# ARKANSAS NUCLEAR ONE - UNIT 1

## IMPROVED TECHNICAL SPECIFICATIONS SUBMITTAL

**VOLUME 4 OF 7**

January 28, 2000

3.4.7  
LCD Note 1

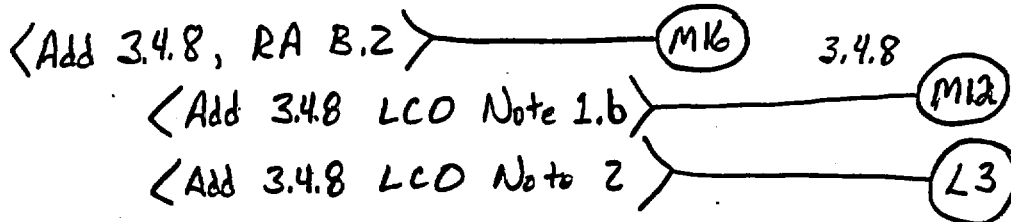
~~removed from operation~~

\*All reactor coolant pumps and decay heat removal pumps may be ~~de-energized~~ for up to 1 hour provided (1) no operations are permitted that would cause dilution of the reactor coolant system boron concentration, and (2) core outlet temperature is maintained at least 10°F below saturation temperature.

FIGURE 3.1.2-1  
RCS INSERVICE HYDROSTATIC TEST H/U & C/D LIMITS TO 31 EFPY**Notes:**

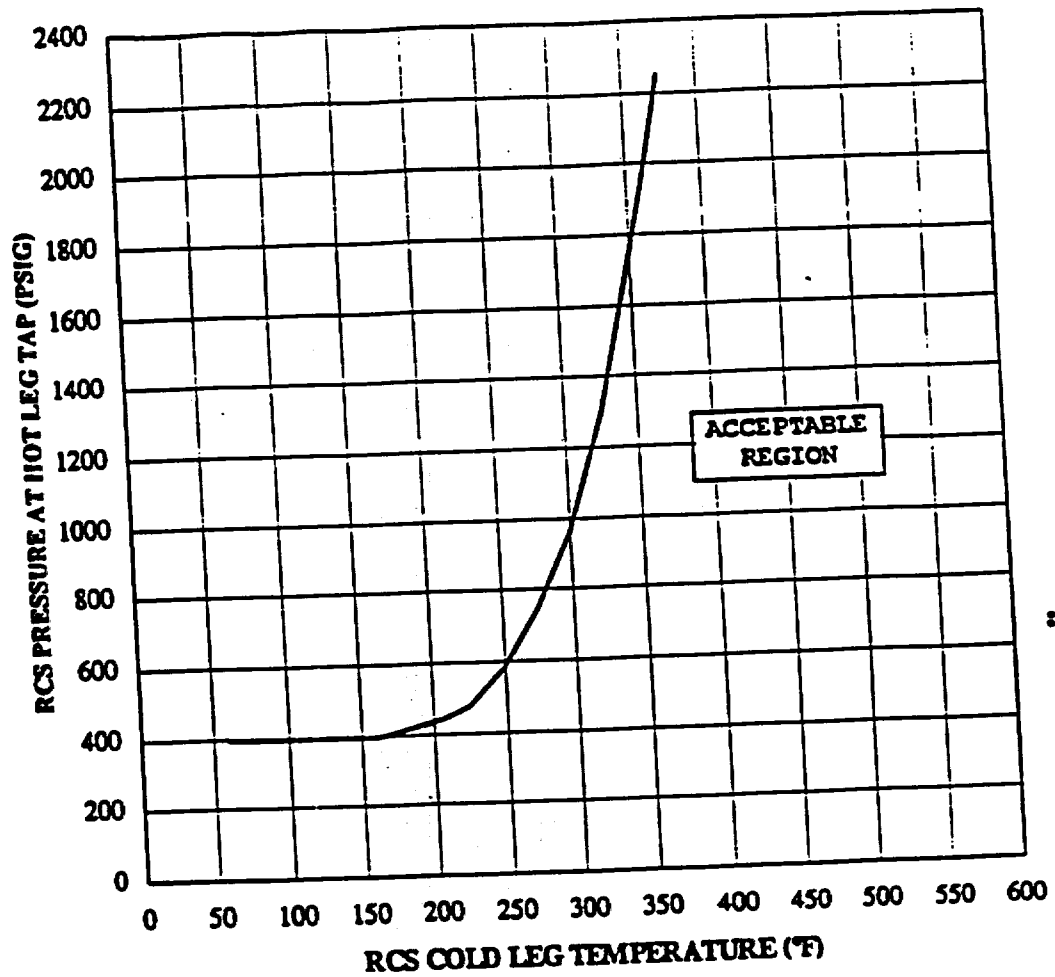
Fig 3.4.3-3

Reviewer's Note: These inserts are revised versions of CTS Figures 3.1.2-2, 3.1.2-3, and 3.1.2-1. They are, respectively, ITS Figures 3.4.3-1, 3.4.3-2, and 3.4.3-3.

FIGURE 3.1.2-2  
RCS HEATUP LIMITATIONS TO 31 EFPY

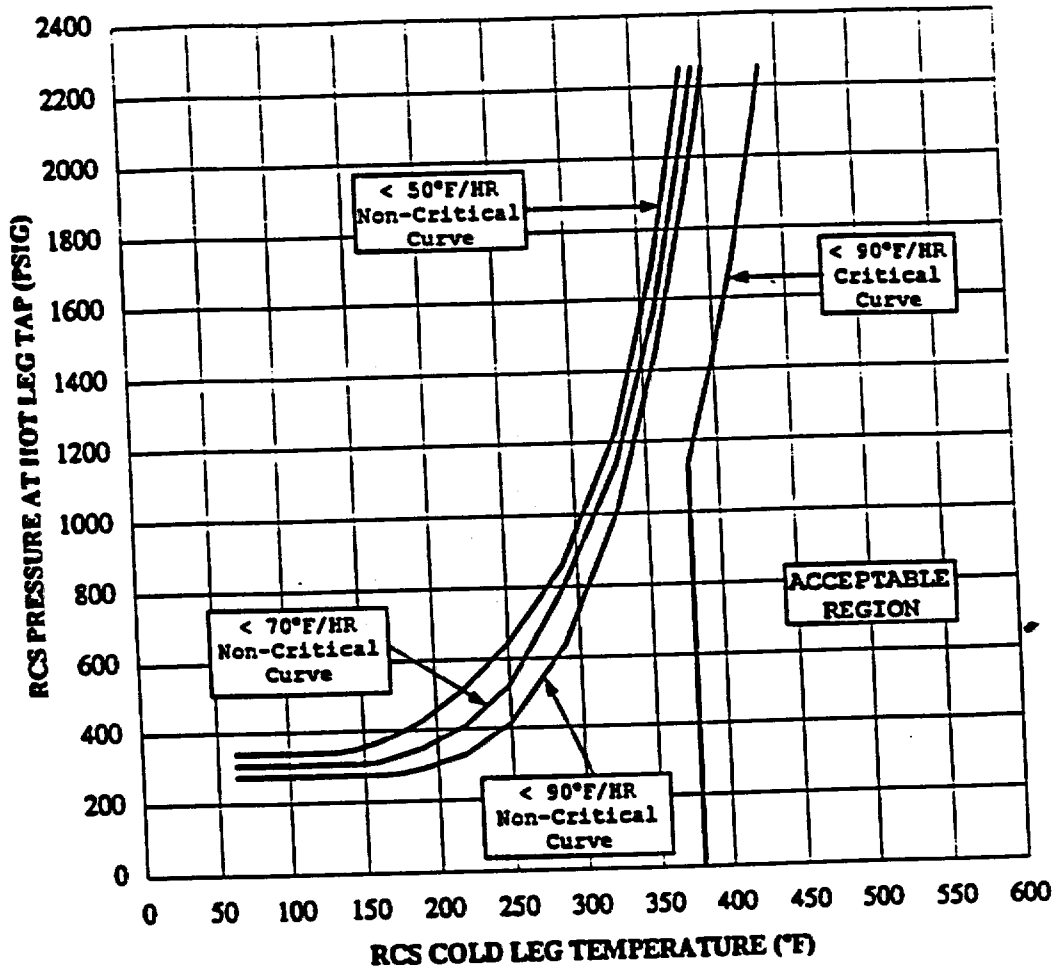
Fig. 3.4.3-1

FIGURE 3.12-3  
RCS COOLDOWN LIMITS TO 31 EPFY

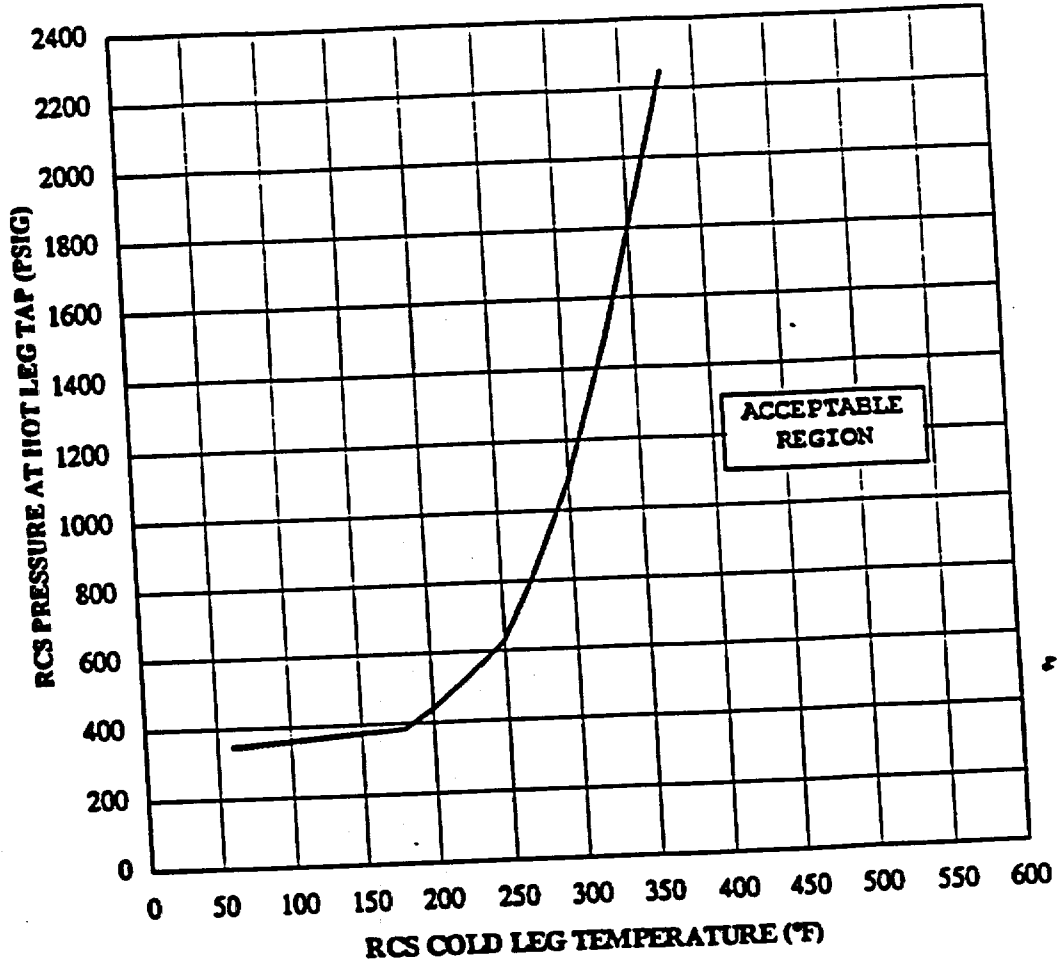
Fig. 3.4.3-2

LCO 3.4.5

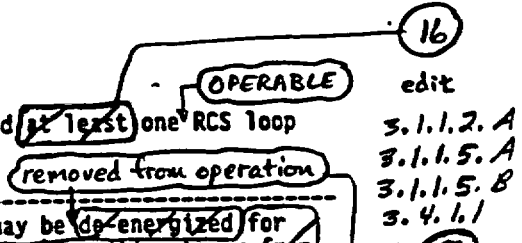
Two RCS loops shall be OPERABLE and ~~at least~~ one RCS loop shall be in operation.

NOTE  
All reactor coolant pumps (RCPs) may be ~~de-energized~~ for ~~3 8 hours per 24 hour period for the transition to or from the Decay Heat Removal System, and all RCPs may be de-energized for 1 hour per 8 hour period for any other reason, provided:~~
